MSO/MST Firmware 2.07.x bug list:

List of bugs/improvement requests

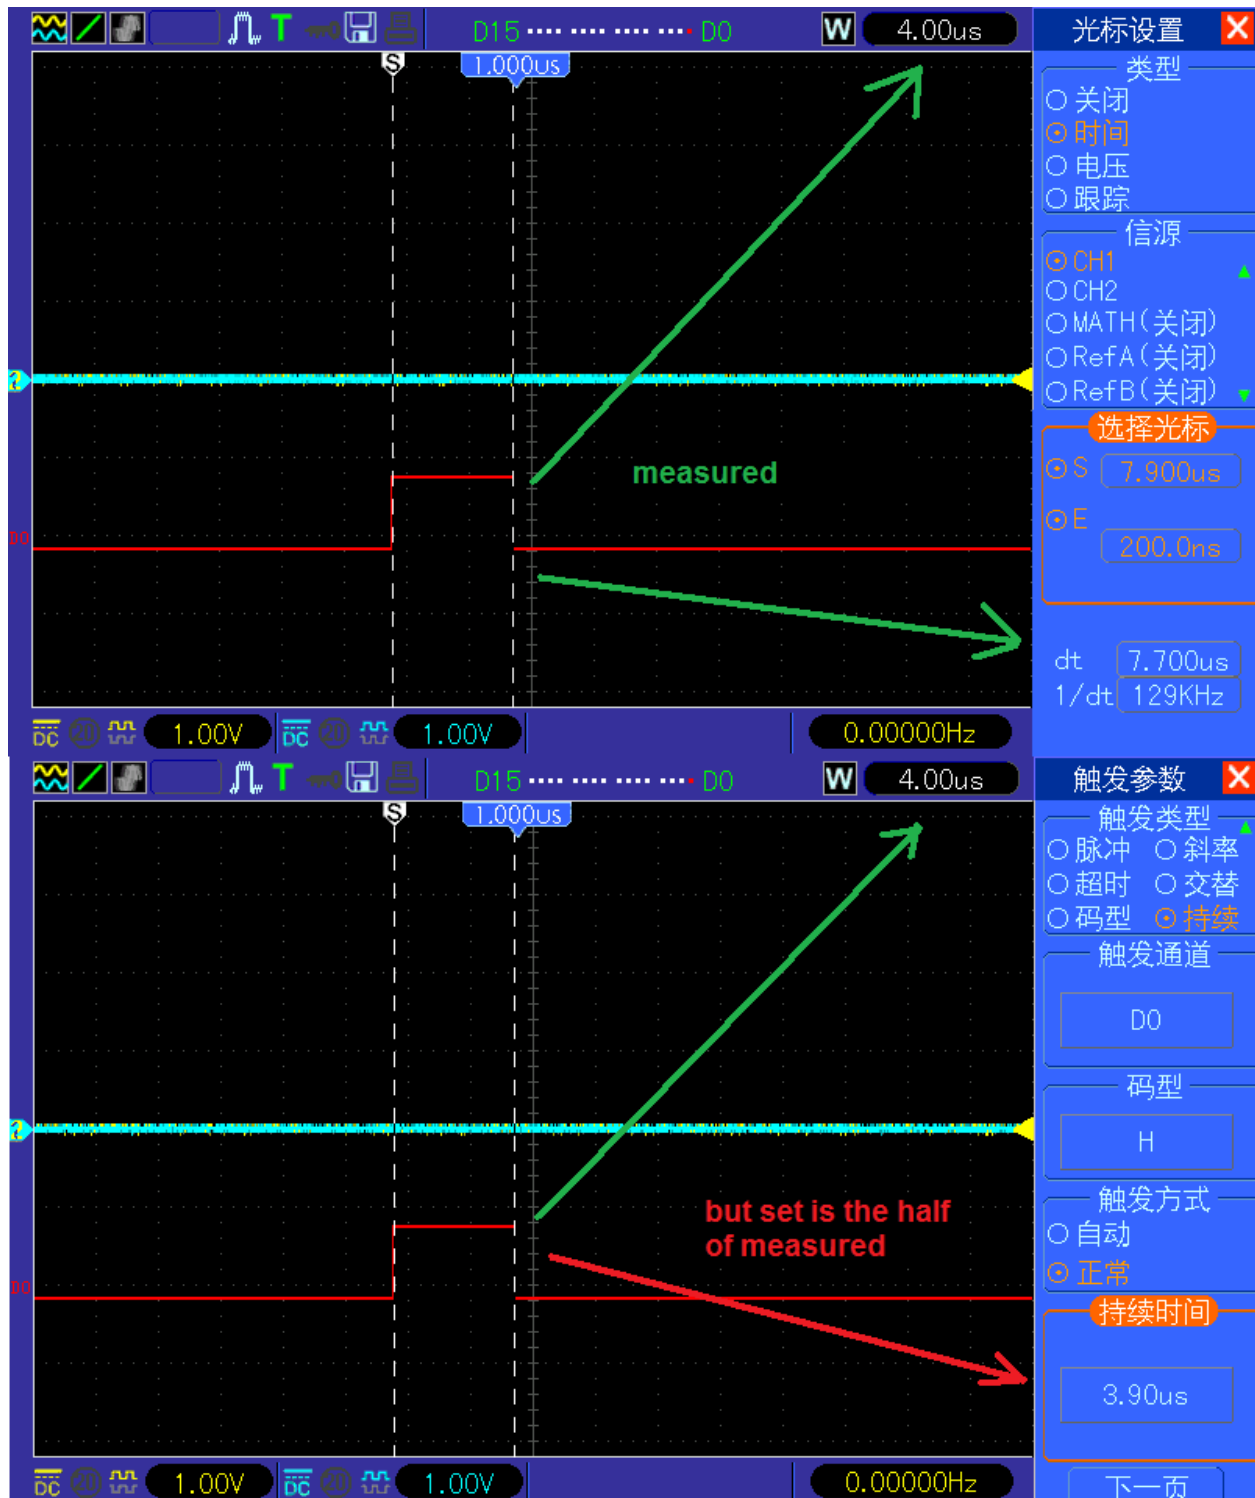
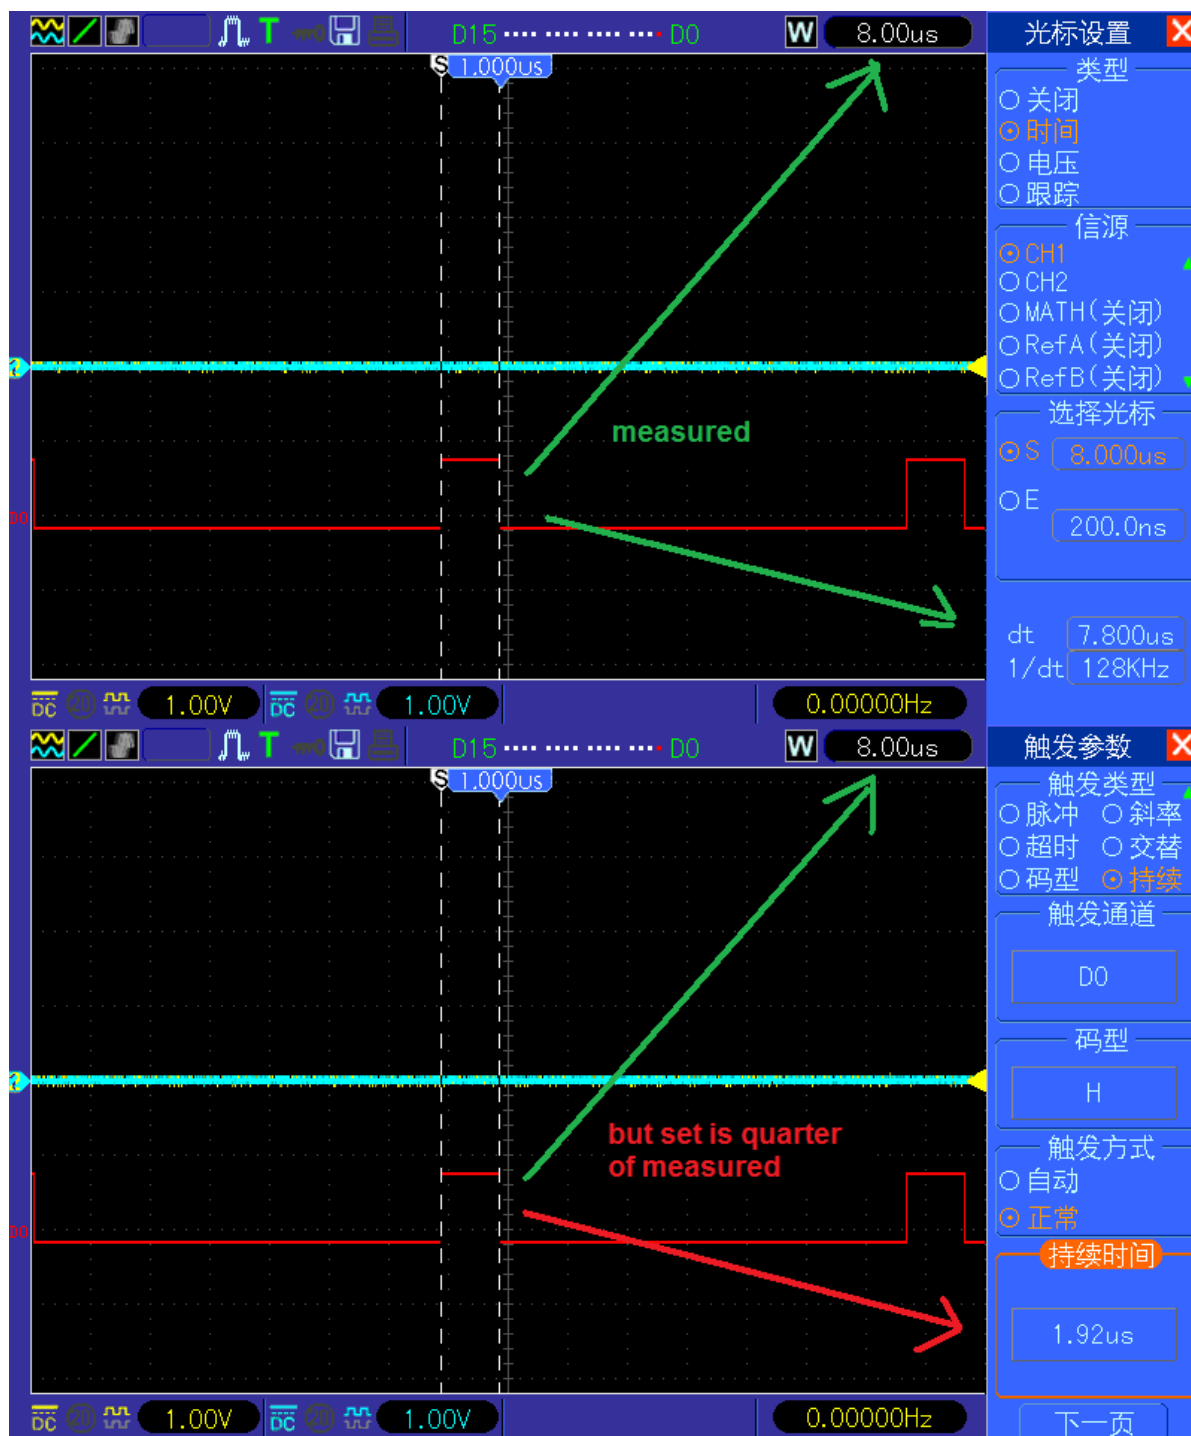
When timebase from 4us to 40ms the duration must be always set smaller and smaller to allow triggering. For example at 4us/DIV i have to set for duration the half of the real value. For 8us/DIV again half of the 4us/DIV value or 1/4th of the real pulse length. For 20us/DIV i need the set the pulse width / 2.5 / 2 / 2 to get the delayed data triggered. I have NOT tested bigger values than 2ms/DIV, this is because the resolution of LA is not allowing such small values (less than 10ns), but it seems that the whole range 40ms/DIV to 4us/DIV is affected by the "divide / 2 or 2.5" error:

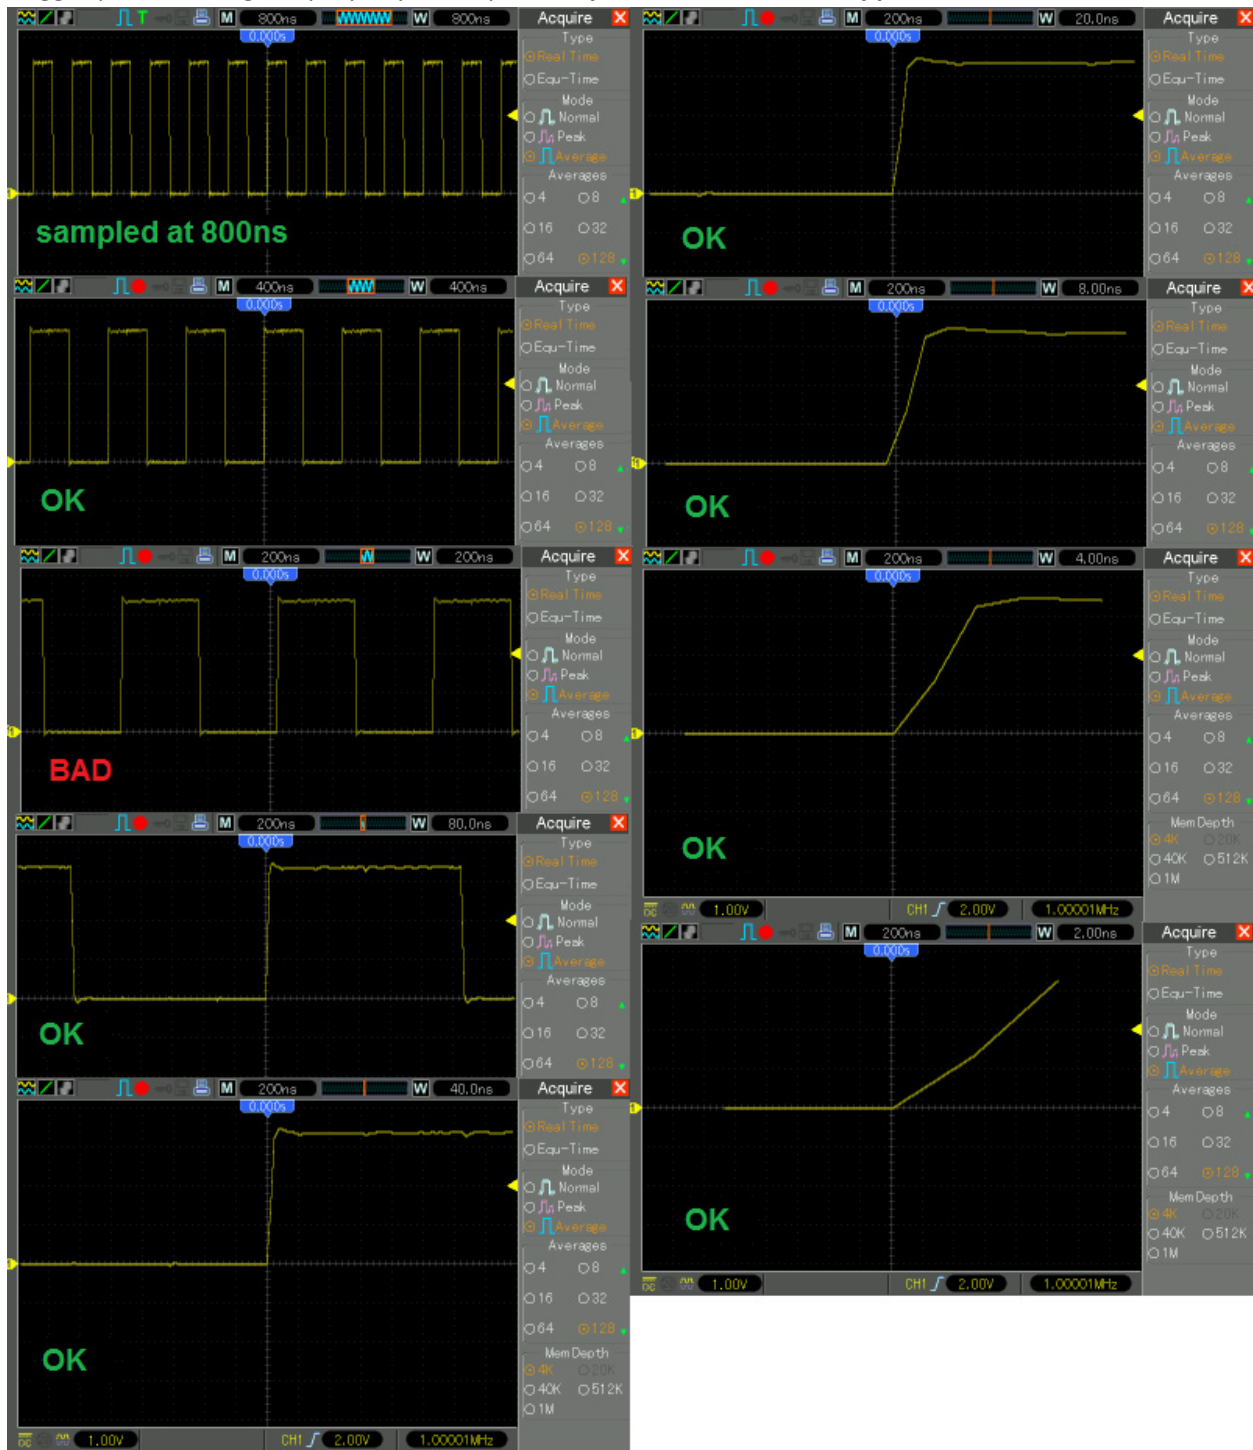
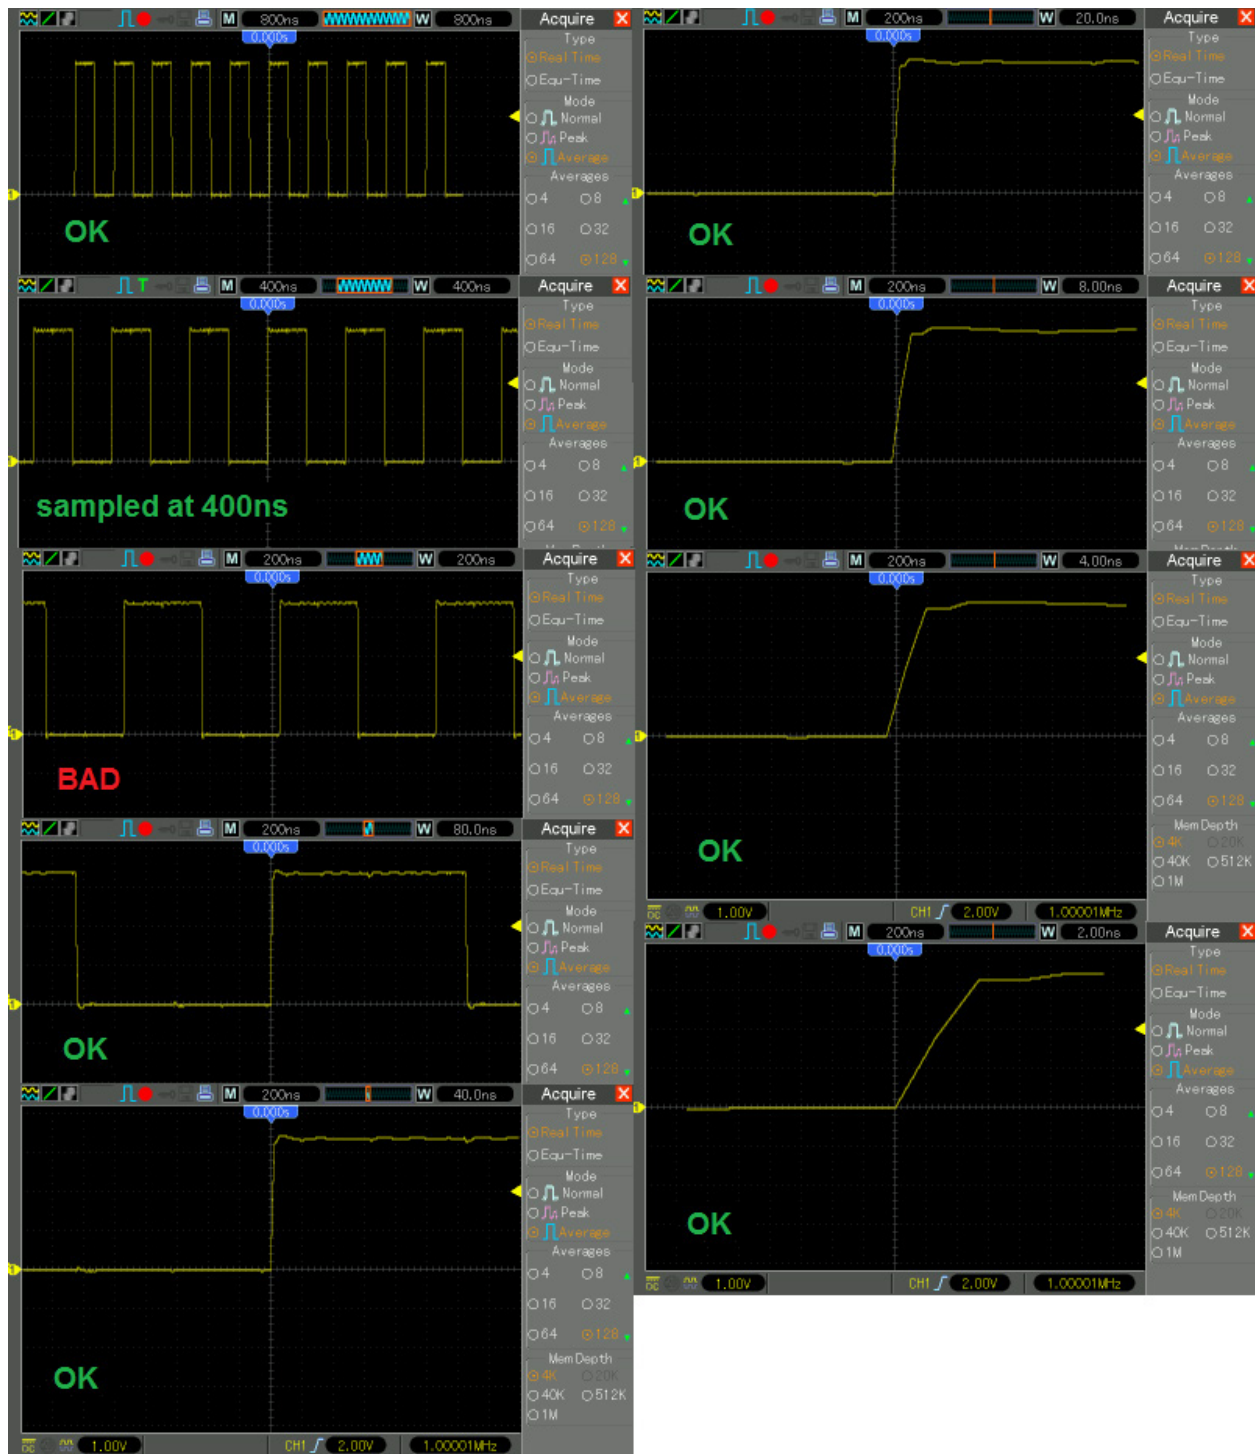
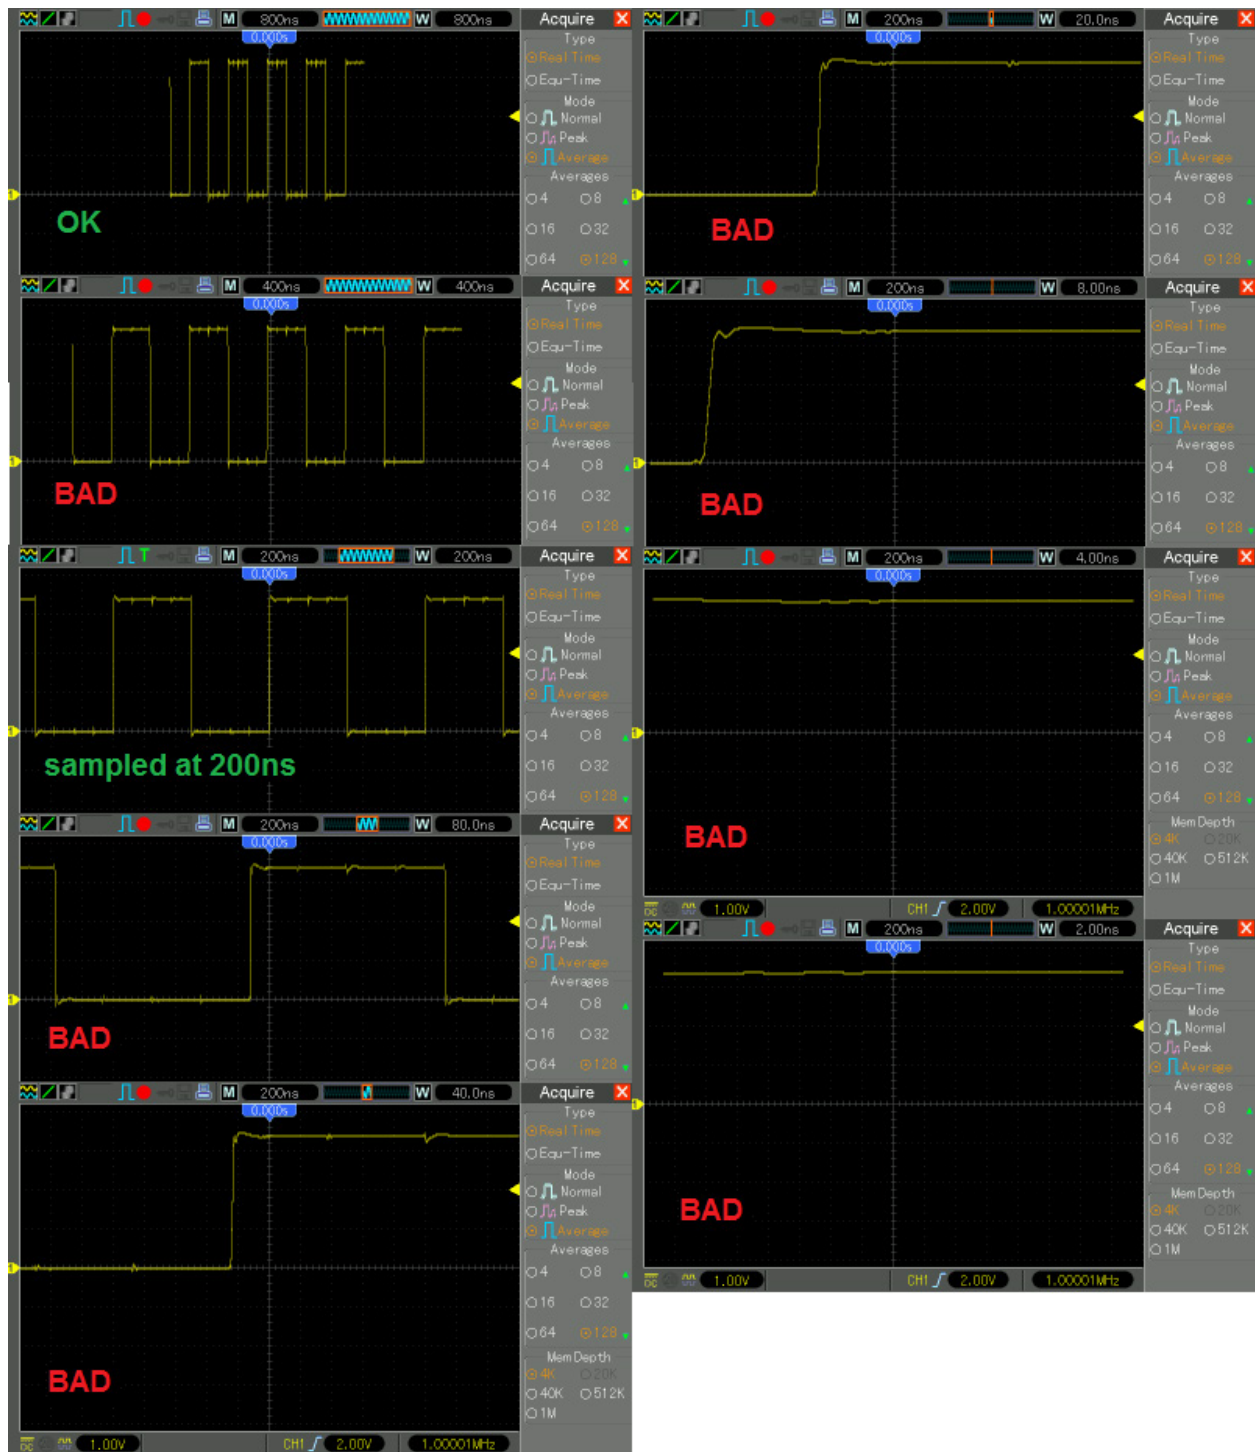
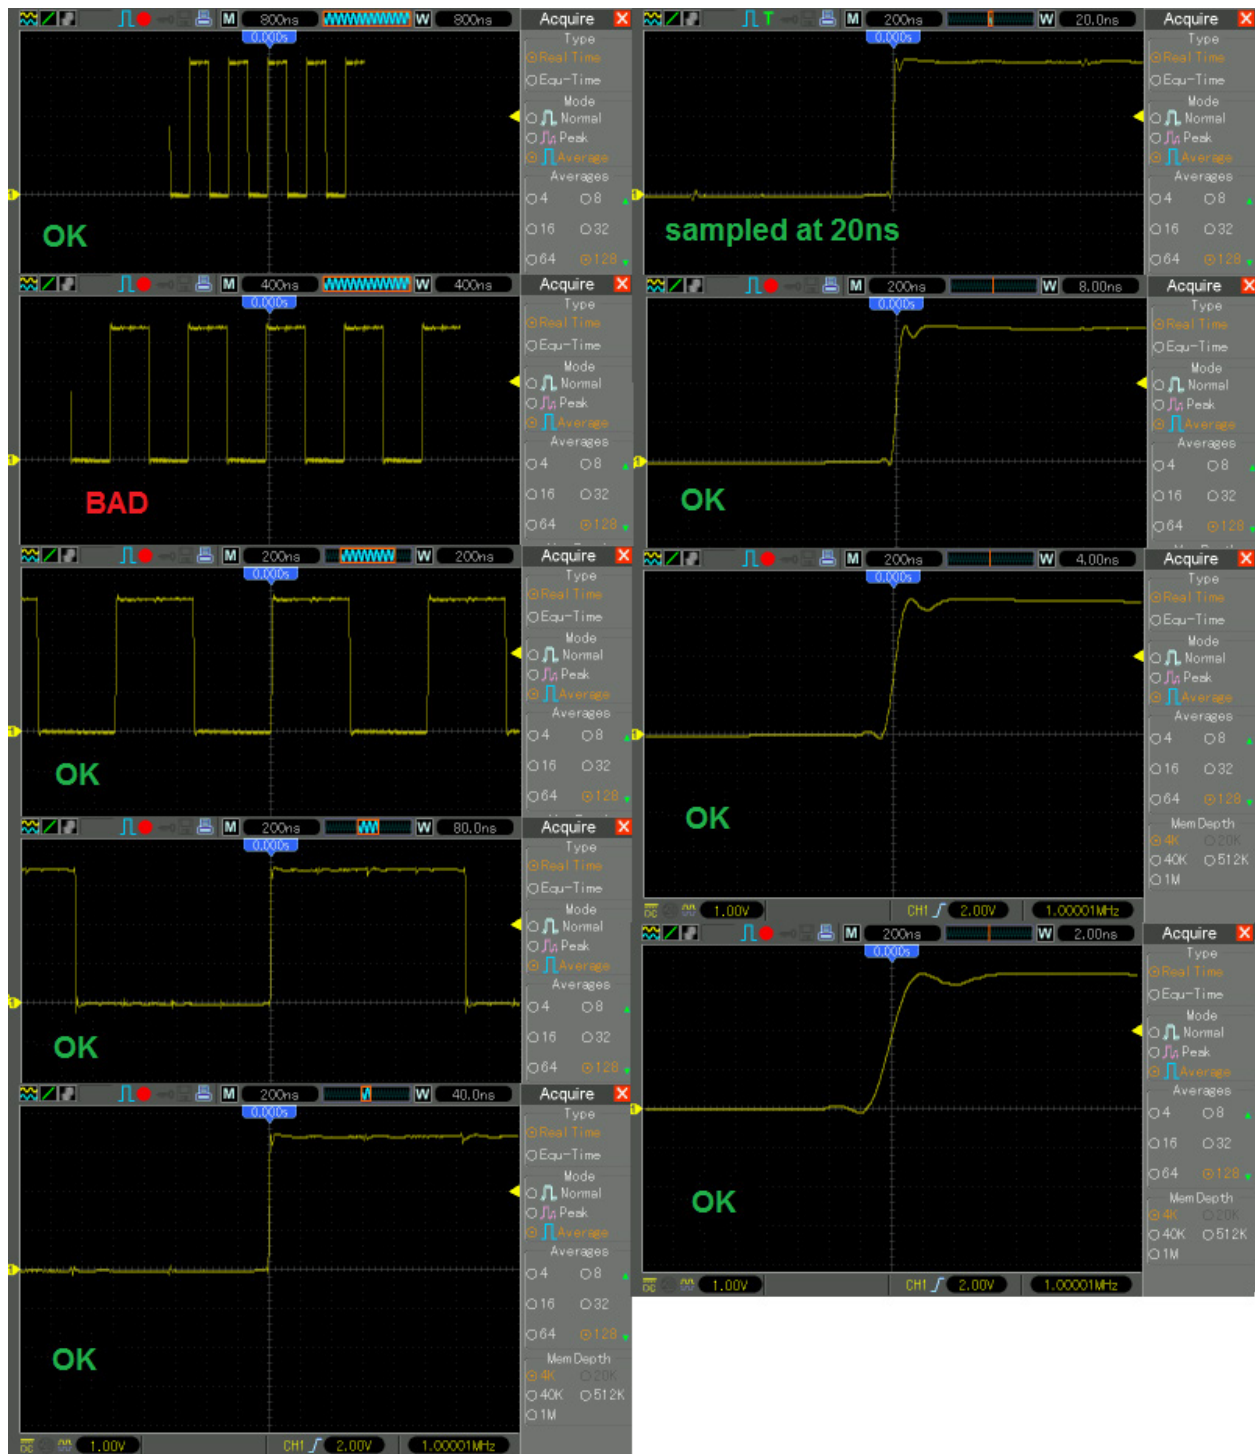
51. Trigger point not aligned properly, example: **sampled at 800ns/DIV, stopped and zoomed:**

sampled at 400ns/DIV, stopped and zoomed:

sampled at 200ns/DIV, stopped and zoomed:

sampled at 80ns/DIV or 40ns/DIV or 20ns/DIV, stopped and zoomed:
